Monticello Nuclear Generating Plant
2807 W County Road 75
Monticello, MN 55362

Monticello Nuclear Generating Plant: Update of Information Related to NRC Order EA-12-049 Mitigation Strategies for Beyond-Design-Basis External Events (TAC No. MF0923)

Monticello Nuclear Generating Plant Implementation of Required Action by NRC Order EA-12-049 Mitigation Strategies for Beyond-Design-Basis External Events

Figure CI 3.2.1.1.E – 1 – MNGP Core Level during ELAP Event

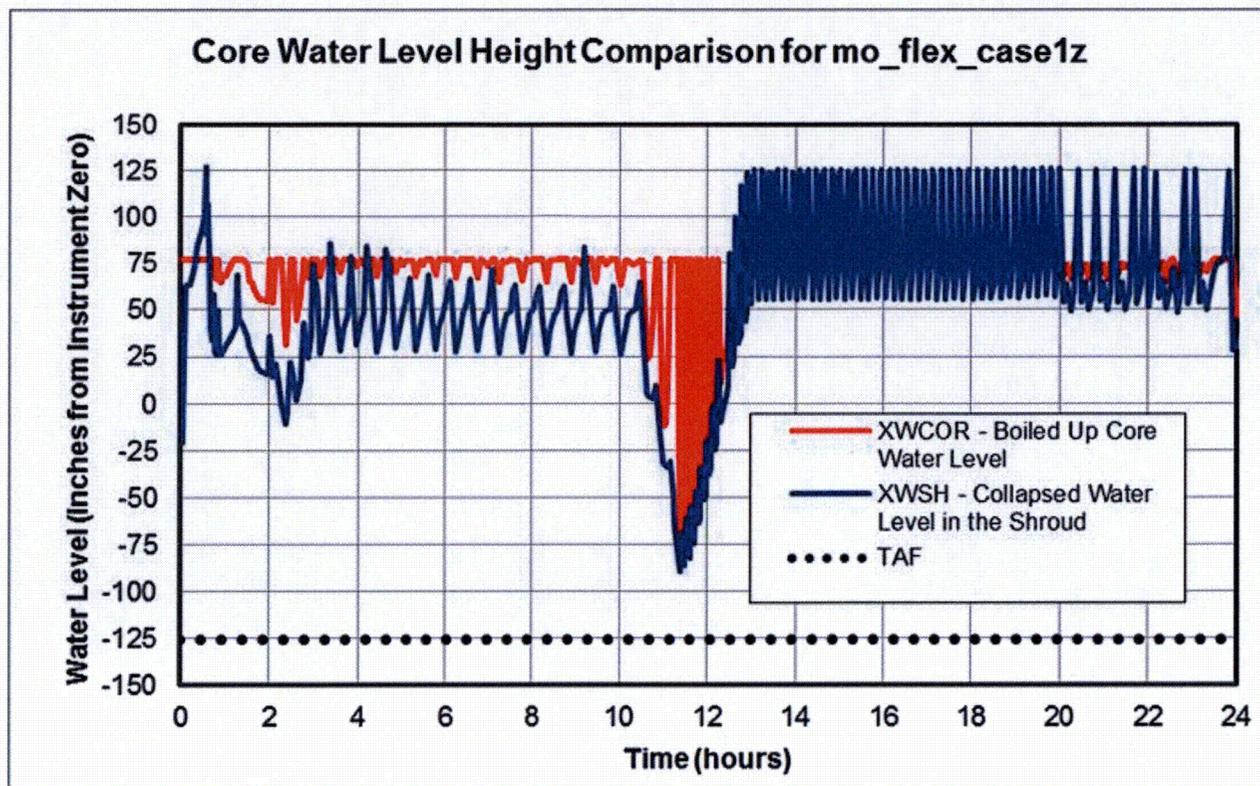
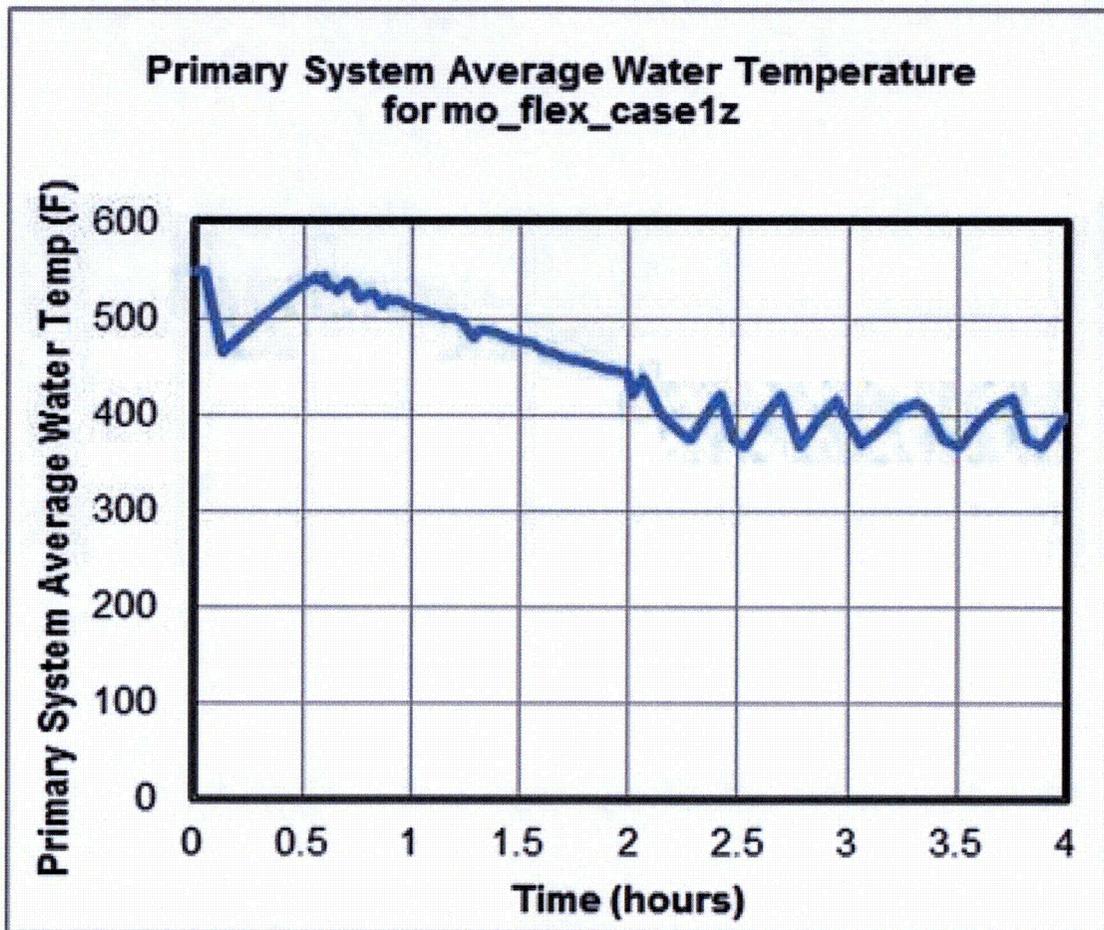
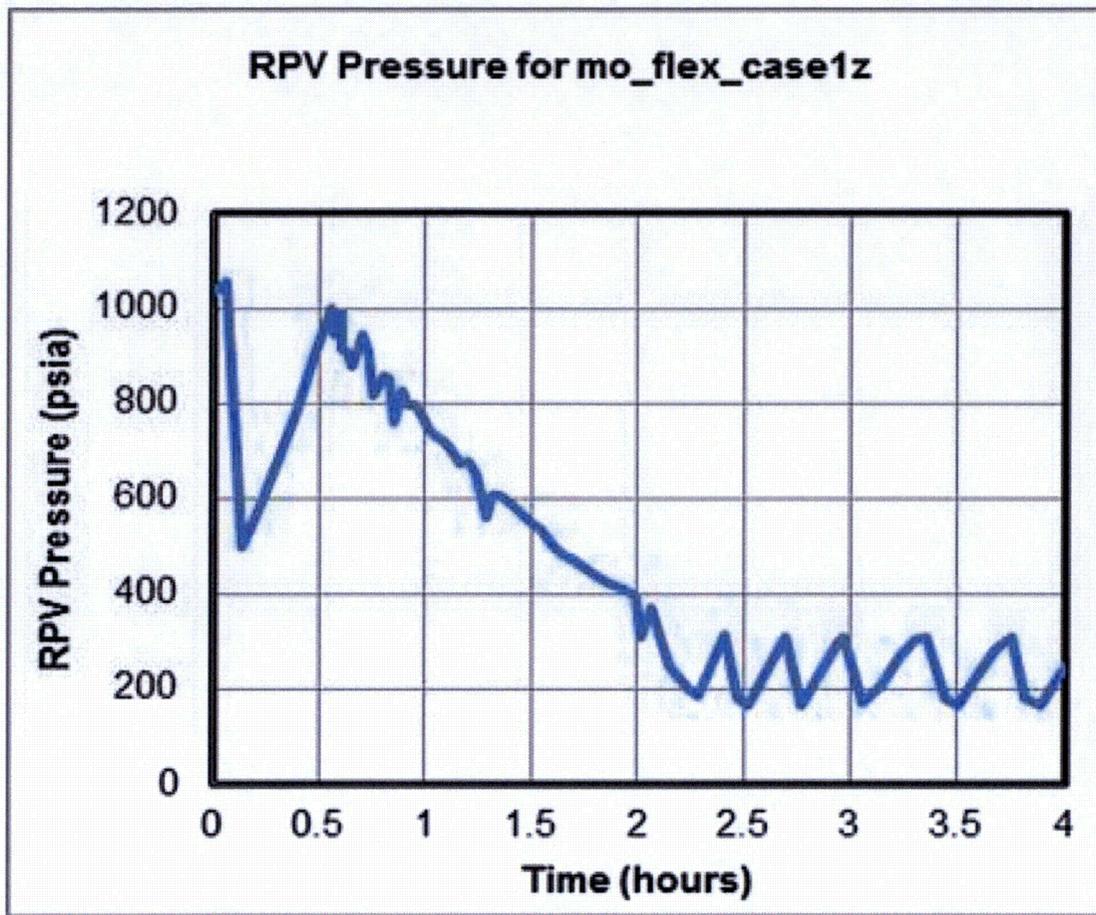
Identify the specific MAAP analysis case that was used to validate the timing of mitigating strategies in the integrated plan and state that it is available on a web portal for NRC staff to view. Alternately, a comparable level of information may be included in the response to the question. In either case, the analysis should include a plot of the collapsed vessel level to confirm that TAF is not reached (the elevation of the TAF should be provided) and a plot of the temperature cool down to confirm that the cool down is within tech spec limits.

The MNGP MAAP Analysis modeled several scenarios representative of the OIP and performed a case that is defined as the representative case for the Monticello ELAP strategy. The analysis considers collapsed RPV water levels as indicated by instrumentation (parameter XWSH) and boiled-up water levels in the core (parameter XWCOR). Figure CI 3.2.1.1.E – 1, below illustrates the vessel water level relative to instrument zero (-126") over the scenario duration (24 hours) ELAP case. Note that neither the collapsed nor boiled-up water level parameters indicate that fuel was uncovered.

Figures CI 3.2.1.1.E – 2 and CI 3.2.1.1.E – 3 illustrate primary system water temperature and RPV pressure, respectively, during the RPV cooldown phase for the ELAP case. These figures indicate that the cooldown rate was maintained $<100^{\circ}\text{F/hr}$, within the TS limits. Figure CI 3.2.1.1.E – 2 indicates the RPV coolant temperature drops from 550°F to 400°F over the period from 0.5 hours to 2.2 hours. This corresponds to approximately a 90°F/hr cooldown rate.
